HEFLIN POLICE STATION
850 Ross Street
Heflin, Alabama

ADDENDUM NUMBER THREE

January 9, 2026

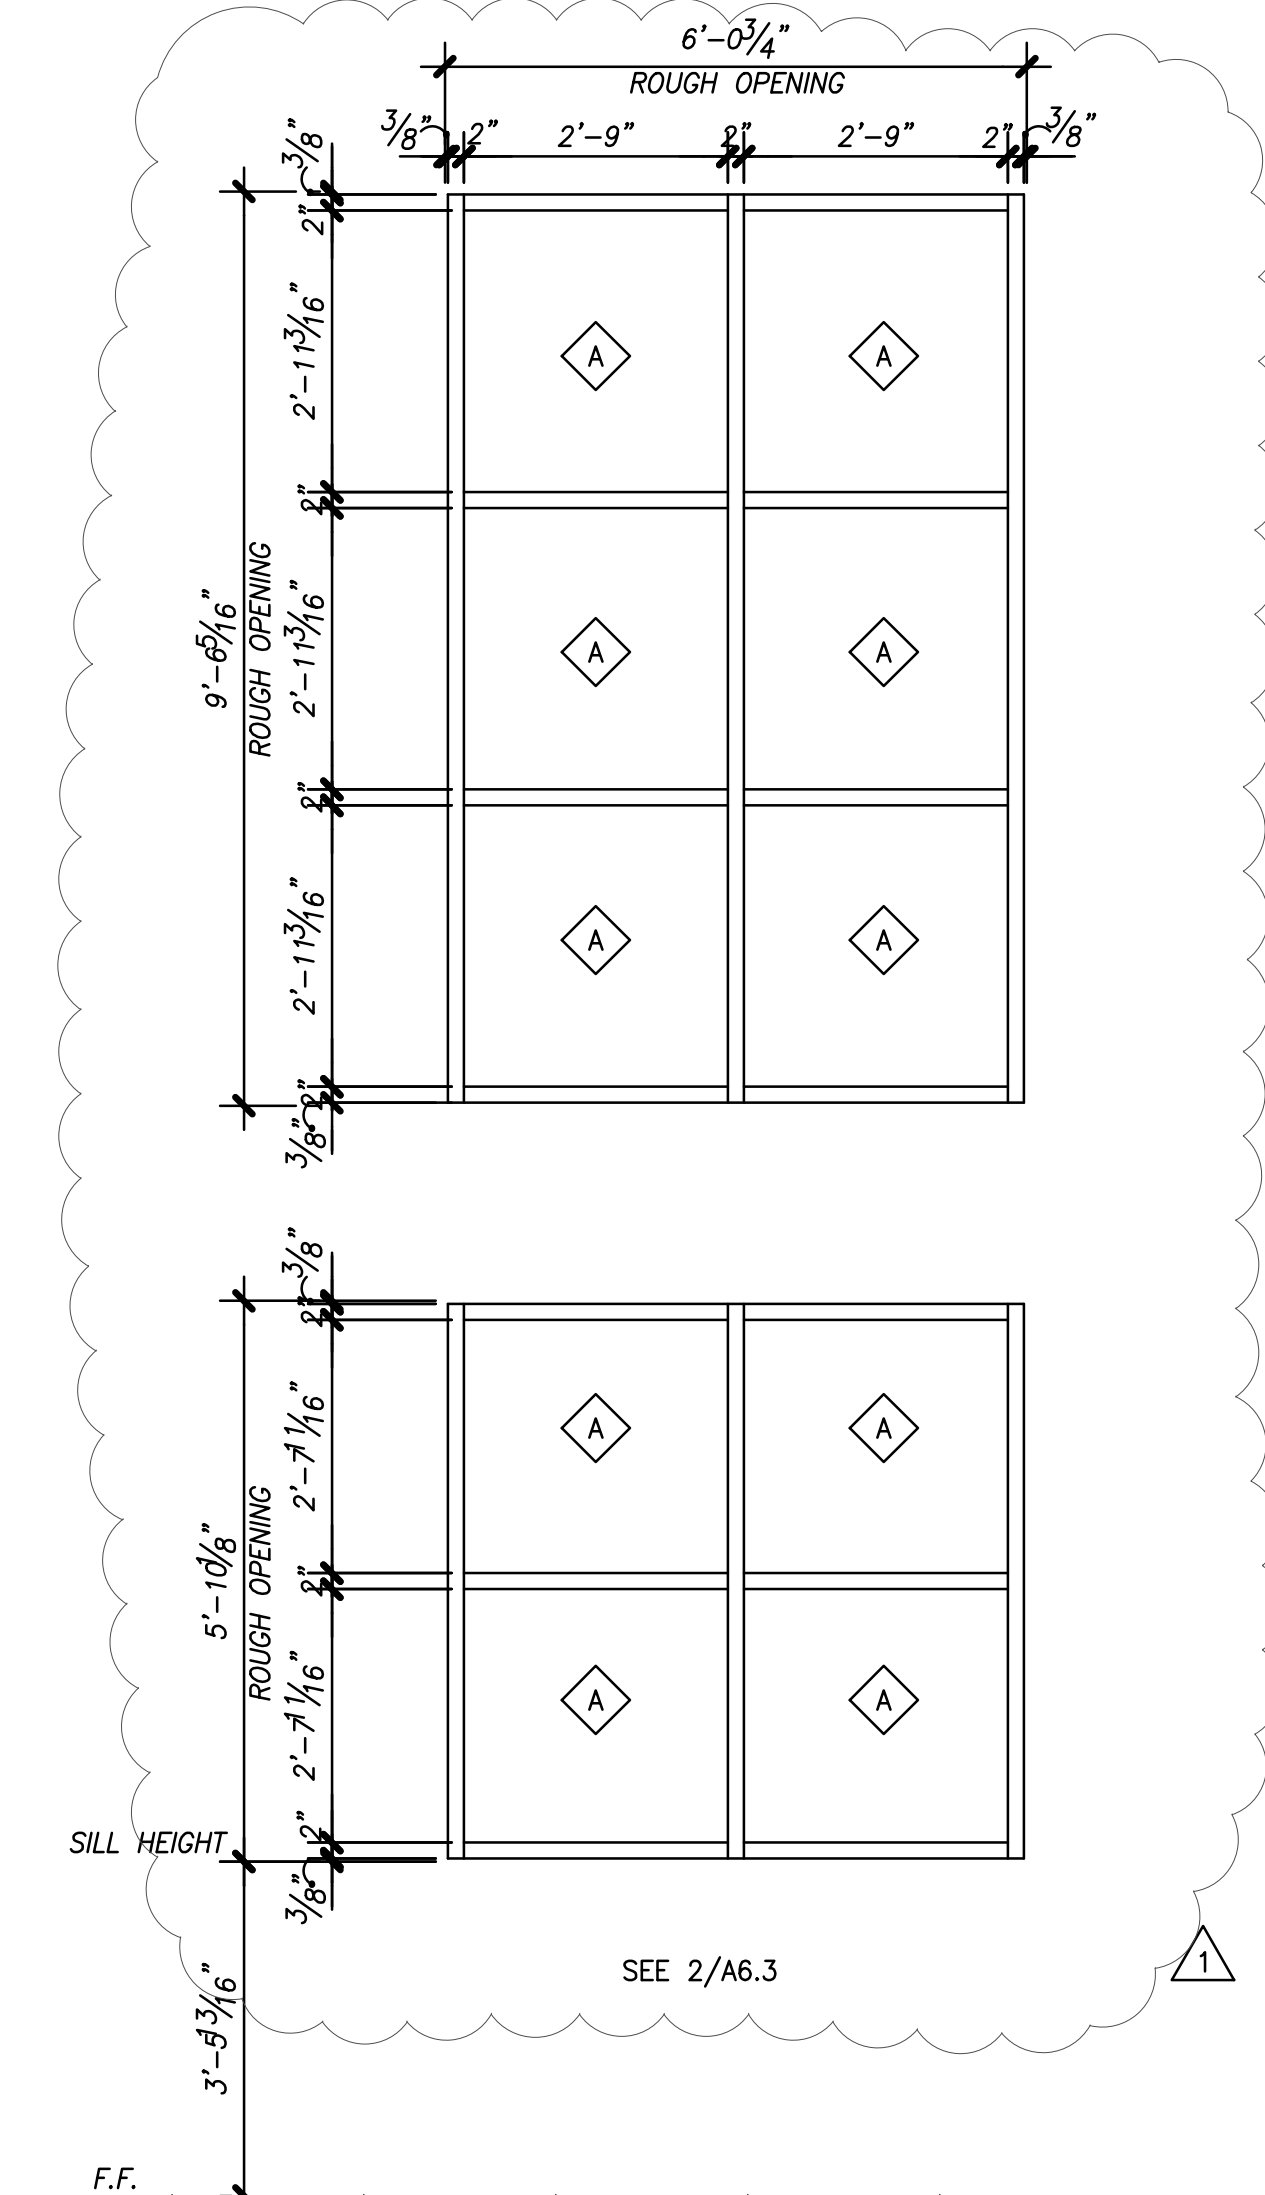
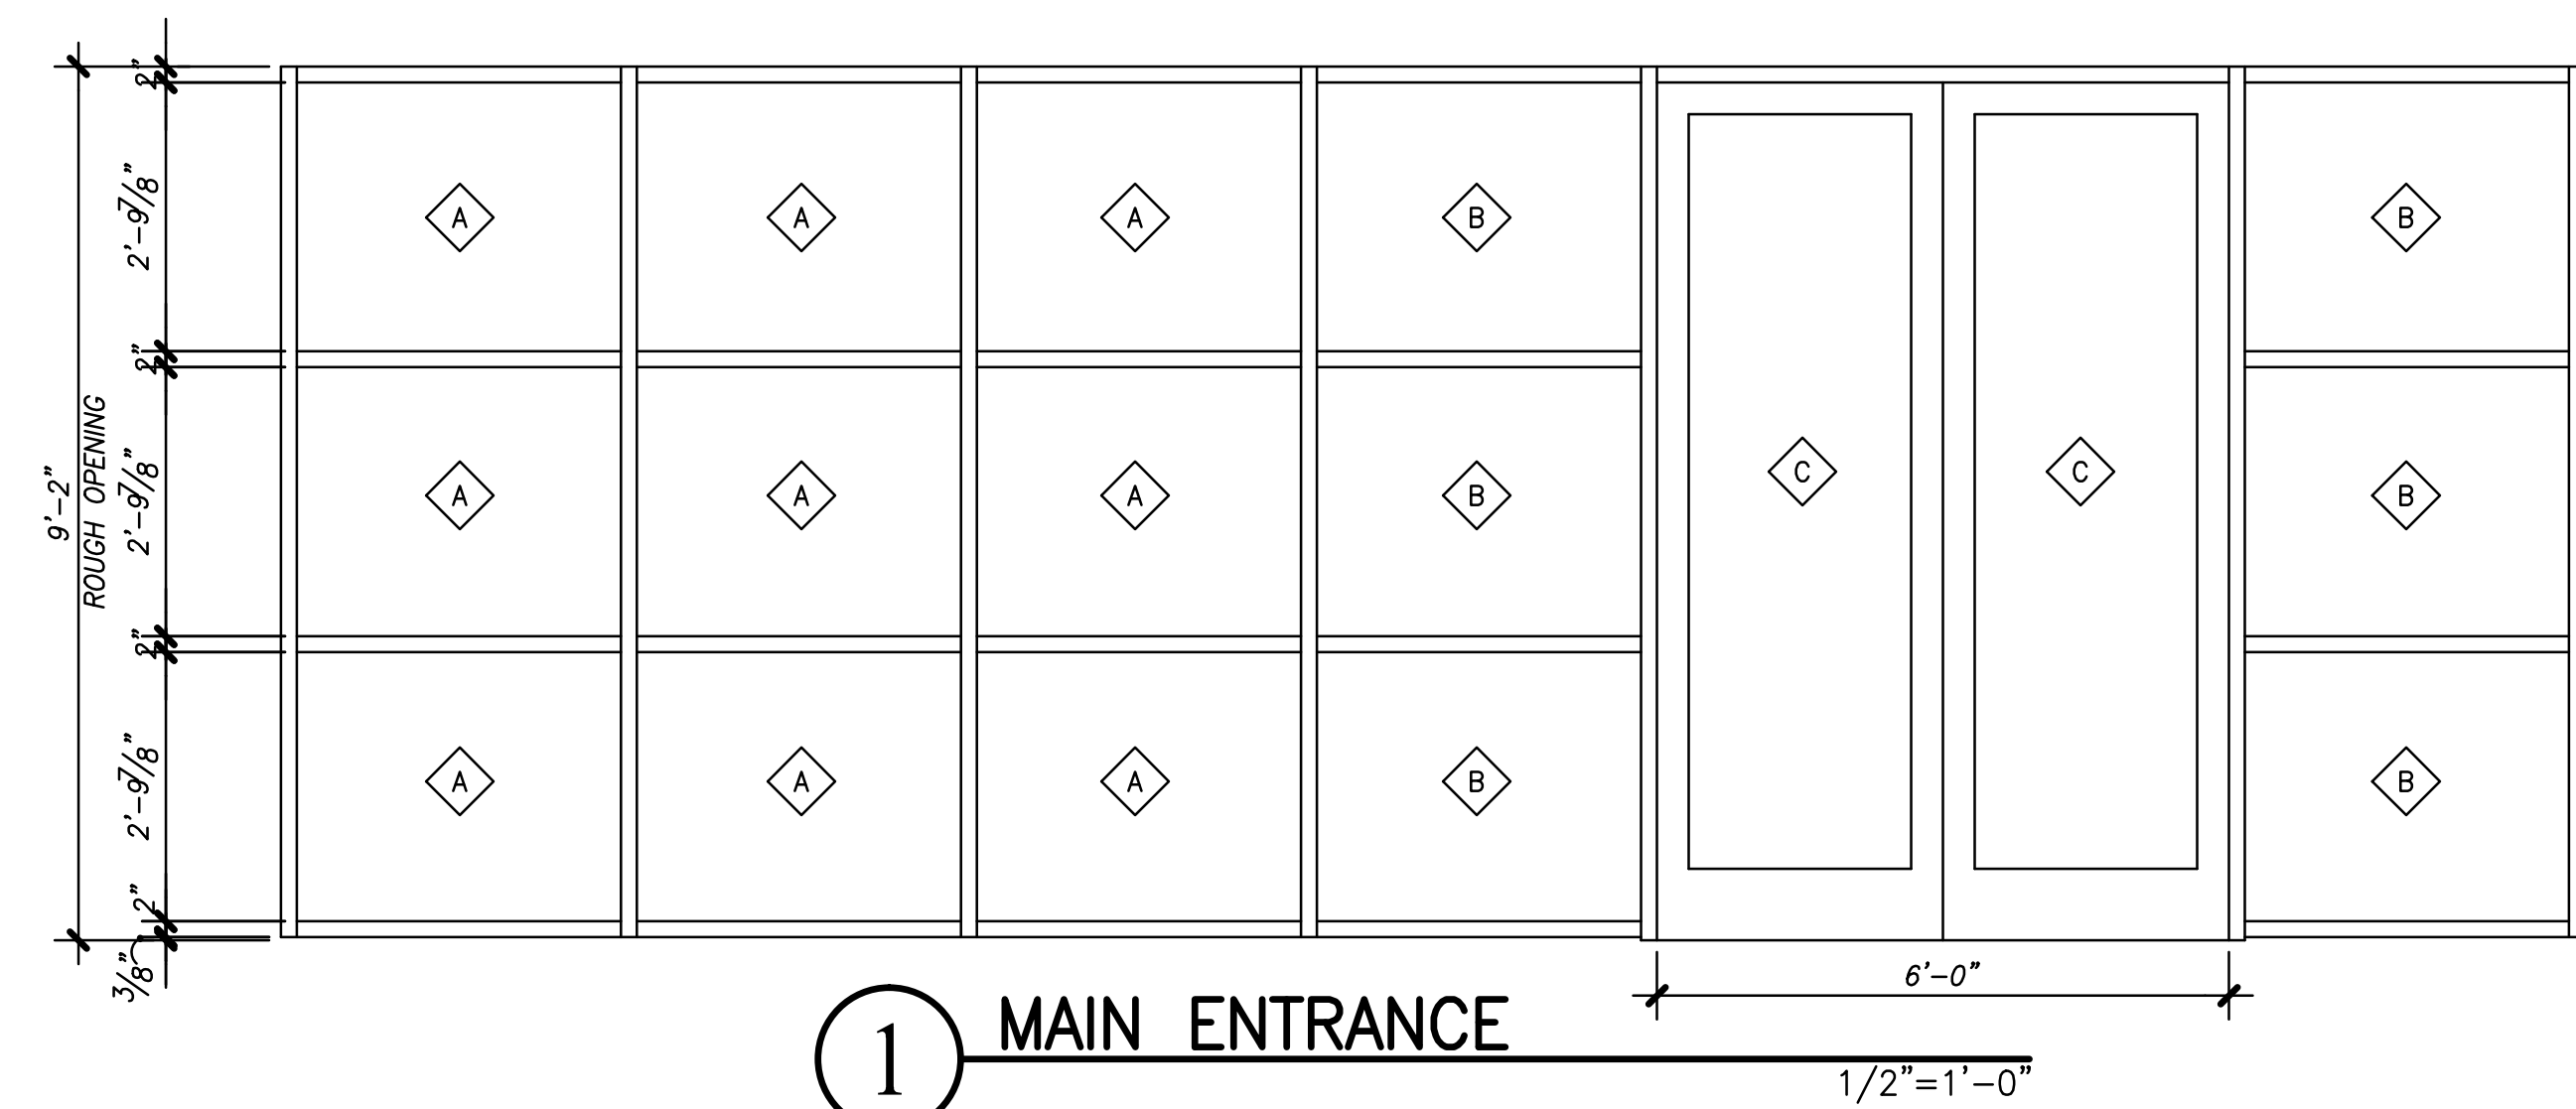
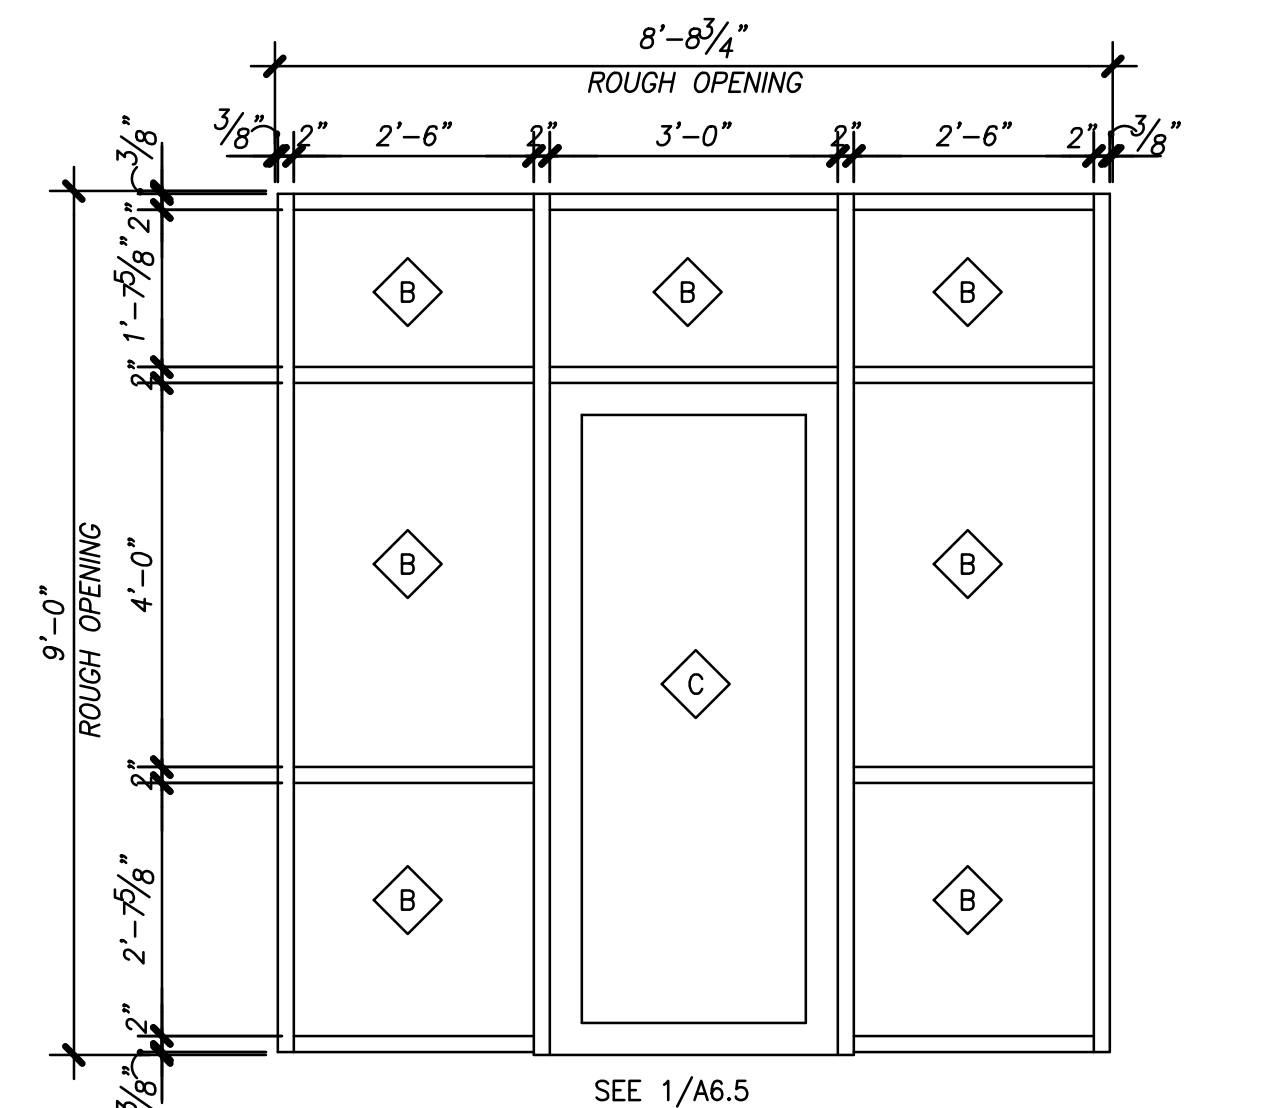
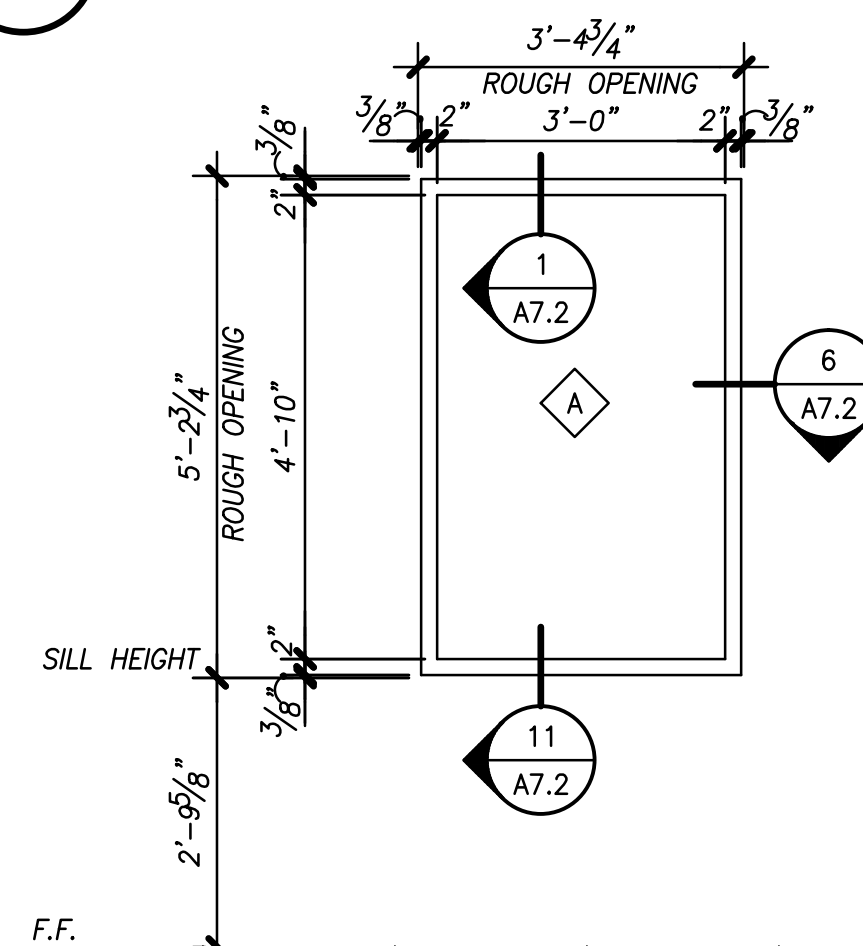
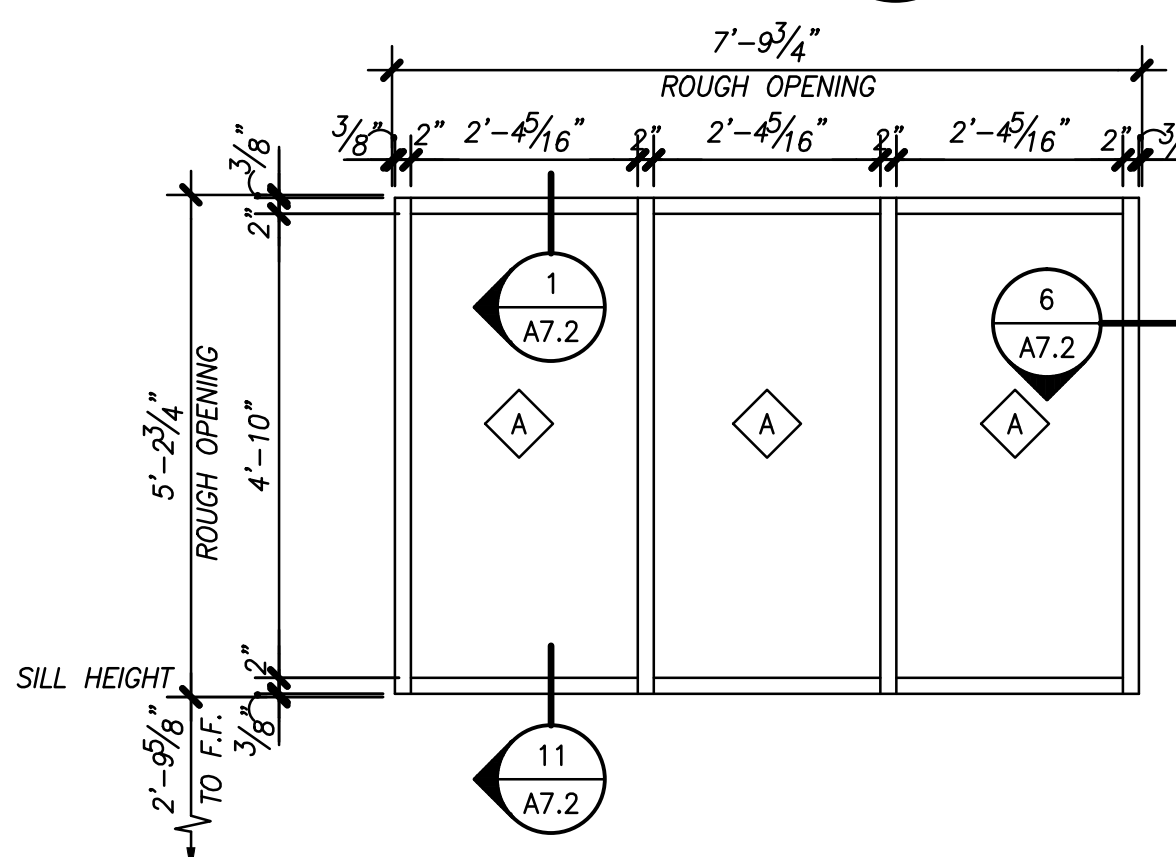
7. Replace A4.1 with the attached A4.1 revised January 9, 2026 to indicate modified storefront at the North Elevation.
8. Replace A4.2 with the attached A4.2 revised January 9, 2026 to indicate modified storefront at the North Elevation.
